World Forum for Harmonization of Vehicle Regulations

Working Party on Lighting and Light-Signalling

Proposal for draft amendments to Regulation No. 70 (Rear-marking plates for heavy and long vehicles)

Submitted by the expert from the European Association of Automotive Suppliers*

Figure 3a

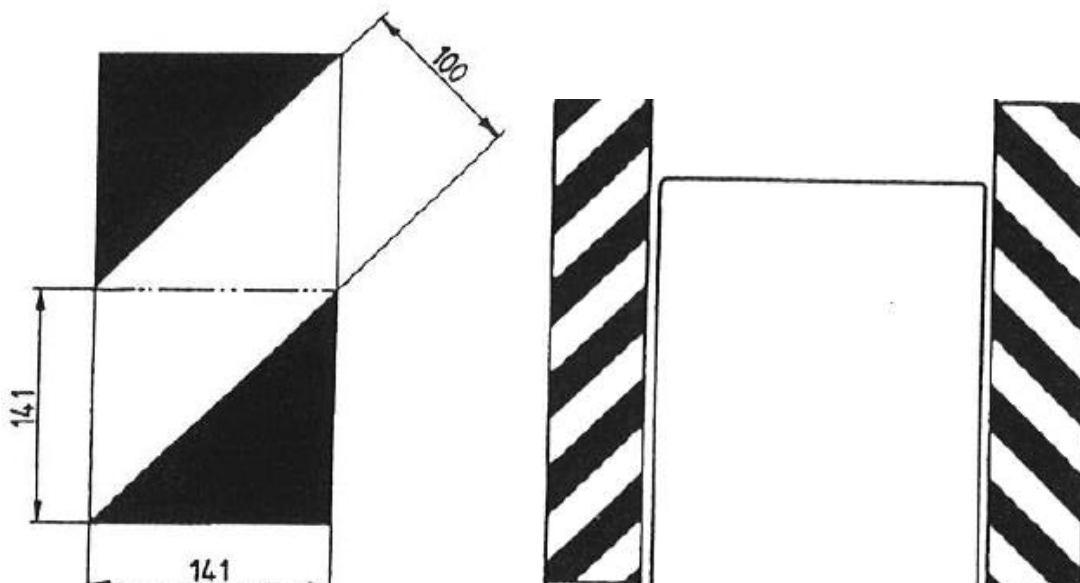
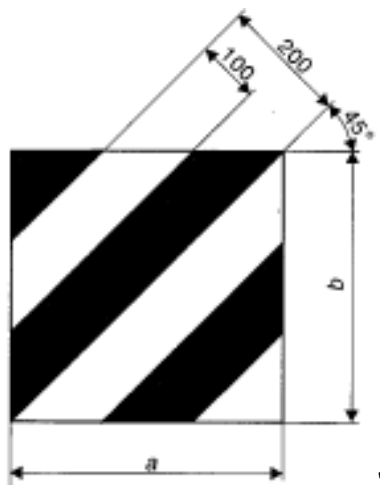
Class 5 retro-reflective materials shall consist of red and white diagonal stripes each 100 mm wide sloping outwards and downwards at 45°. The basic standard area is a square of 141 mm in length subdivided diagonally into a white half and red half, which represents one standard area.

Prescribed shapes, patterns and dimensional features of Class 5 devices are illustrated in figure 3 of Annex 12 to this Regulation.

Annex 12, insert a new title after Figure 2 and insert new Figure 3:
